MICROLIGHT AIRWORTHINESS APPROVAL NOTE

MAAN NO: 2336

TITLE: Microlight Airworthiness Approval Note 2336: Shadow Fuel Tank Deterioration

Reference: BMAA Service Bulletin 2336 Issue 1
Title: Fuel Tank Deterioration
Applicability: All BMAA-administered Shadows
Author: Adrian Jones, Design Approval Engineer, BMAA
Effective date: 21 March 2011
Classification: Essential

Figure 1: Shadow Fuel Tank Construction

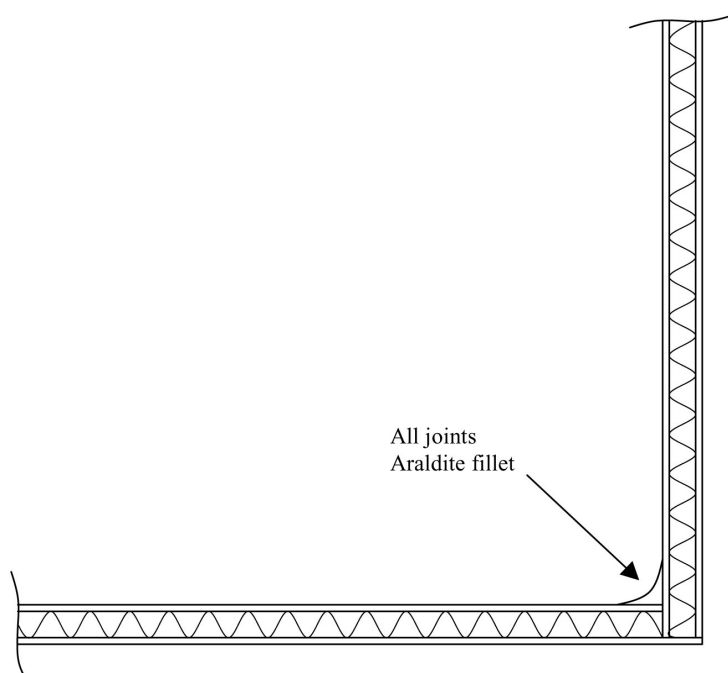
They are constructed from flat 1/8" thick panels, rebated and bonded together at their edges with epoxy. Figure 1 shows a typical edge joint showing a neat fillet of epoxy. After assembly, but before the top is bonded on, the interior of the tanks is coated with a thin layer of epoxy. The fuel outlet hole is then screened by a plastic 'tea strainer' bonded onto the floor of the tank. After bonding on the top a small amount of epoxy is poured into the tank to coat the top panel. It is not possible to neatly fillet the top edge joints as with the rest of the tank.
